Water Supplies Department

檔號
Reference (5) in WSD 3321/18 Pt.1 T/J(291)

Approval of "K&E Technology" Float Operated Valve

FV180

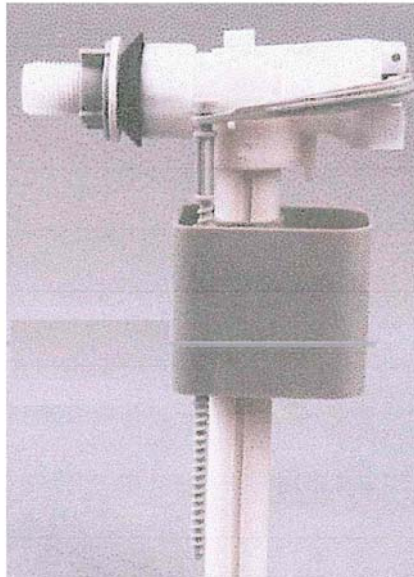
Name of Manufacturer:	Xiamen Bestter Plumbing Co Ltd
Country of Origin:	China
Brand:	K&E Technology
Details of Fitting:	1/2" Plastic side inlet float operated valve
Model:	FV180
Body Markings:	K&E Technology
Expiry Date:	1 February 2023

Proviso: As the fitting has not been tested for use in contact with water intended for human consumption, the fitting can only be used in flushing water plumbing system.

This Authority hereby permits the use of the above fitting in flushing water plumbing systems subject to full adherence to Waterworks installation requirements. In particular, you are required to draw your customers' attention to the following requirement-

"The flushing volume of the flushing valve should be adjusted to suit the design of the toilet bowl so that wastes can be cleared effectively by a single flush."

"The maximum flushing cistern volume including that of dual flush cisterns for use in conjunction with the fittings shall not exceed 7.5 litres per flush."

"The fitting should be used within the range of working pressures specified by the manufacturer." AND

"The installed fitting should not result in backflow of water that will contaminate the flushing water supply."
